SPEAK NOTES – WINSTON (BATHROOMS COURSE – PART 2)

CASE STUDY

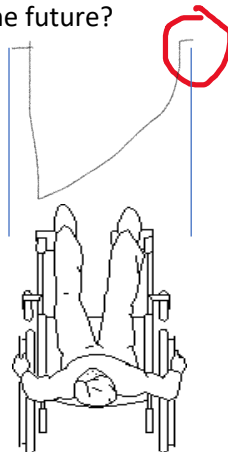
Privacy: lack of privacy (bedroom is through cut to conservatory and back garden)

Natural daylight: no natural light in bedroom. Should bedroom have been where bathroom is? Yes, in terms of lighting but any issues in terms of drainage?

Artificial light: drawing does not show provision and siting of light switches. Particularly important is 2-way light switch by bed so s/u can operate main light if/when confined to bed for periods of time.

Bed: bed is a single one (in terms of size). These are usually 900mm wide x 2000mm long. He will need a profiling bed which will be approximately 1050mm wide x 2200mm long.

Turning circle: smaller than the minimum standard. More for an ambulant person, not a wheelchair user. Was this measured?

Furniture: not shown on drawing. Appears to be little space for essential furniture, such as a bedside table (400x400mm), wardrobe (1200mm x 600mm), chest of drawers (750 x 600mm), desk or even an armchair for a visitor to sit in. Measurements given here are averages for these types of furniture and as required in new wheelchair housing in England.

Sockets: drawing does not show how many are provided, and where they will be sited.

Carers: there is space to one side of bed only. As he will be hoisted, then space will be needed to both sides. Is there sufficient space for this? Potential discussion around how much space needed to help with sit to stand transfers + hoisted transfers.

Doors: point out hatching for the door “infills” i.e hatching is indicating that the old doorways have been filled in with blockwork (is not essential to feedback on this but might be of interest if some delegates have completed the Reading Plans course as we cover hatching on this course).

What was the point of repositioning the door between living room and bedroom (near the entrance to the conservatory). Would have been better to keep it where it was as allows for a bit more privacy for Winston.

Door to conservatory: there is no clear space to the side of the leading edge (pull side) of the door. Very difficult if not impossible therefore for Winston to open door from a wheelchair as will have to lean right across the wheelchair to reach the door handle and then wheel backwards while pulling the door open. Might this be an issue in the future?

Room is too small. internal dimensions are just 2400mm wide x 1300mm long = 3.12 sq m. The Toolkit matrix from earlier in the course that this is less than the sq m required for even an ambulant disabled person. In fact, 3.00 square metres is the recommendation for an ambulant disabled person for a WC only and not a WC shower room. For an assisted user in a WC/Shower room, the recommended sq m is 6.25 i.e. double that shown on the drawing.

Shower-Loo wet room: have they considered converting the bathroom into (a) wet room that is (b) a shower-loo i.e. WC pan functions as a shower seat.

Shower-loo cubicle: would they consider a cubicle instead of a bathroom e.g chiltern invadex?

Door to bathroom: remove completely? Sliding door?

Radiator by WC pan: potentially blocking a shower-commode chair

WHB: potentially in way of carer trying to assist Winston on/off WC

Siting of shower controls: should these be on wall outside shower if used by carers only (to avoid them getting wet)?
